103.1061.01

IN THE DRAWINGS:

Fig. 3/4

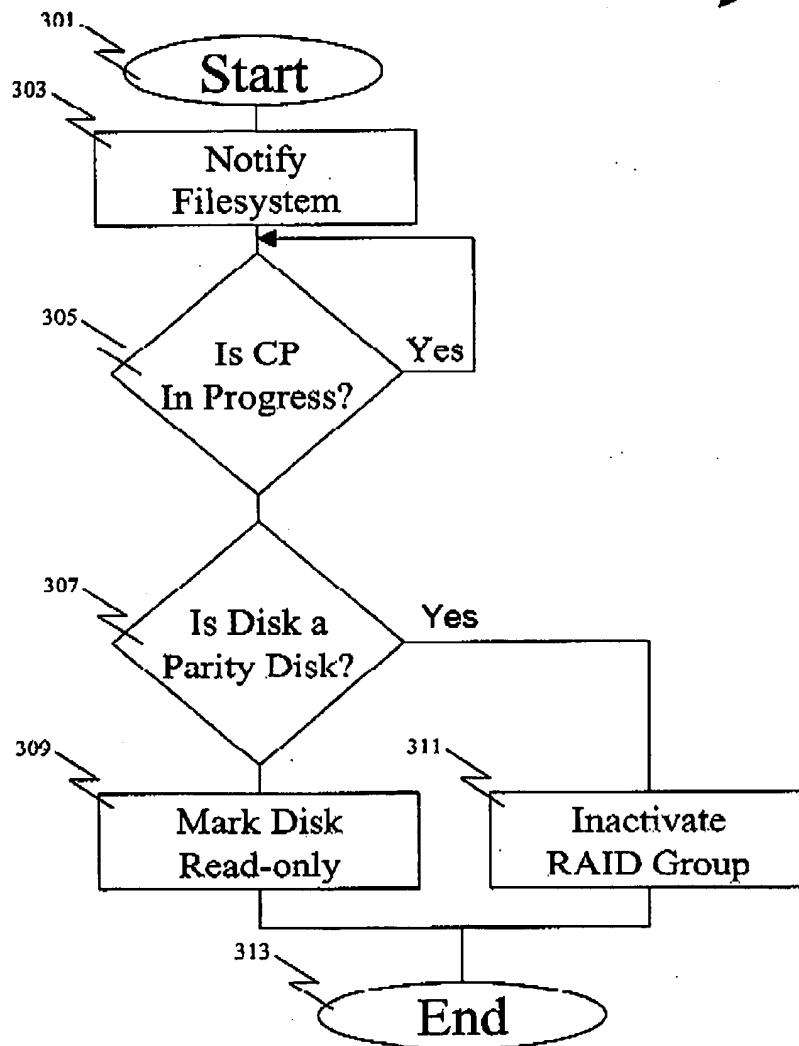
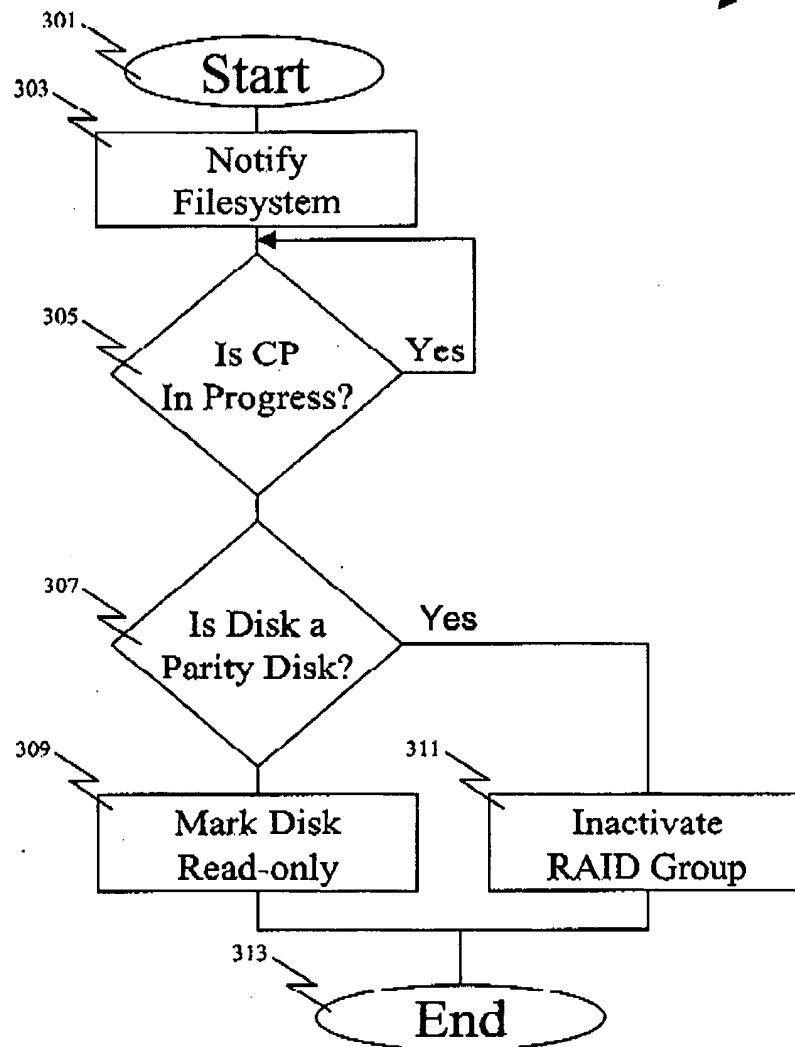
A replacement figure 3 accompanies this response. The figure has been amended to show the "path-selecting value" for the flow diagram at step 307, as required by the Office Action.
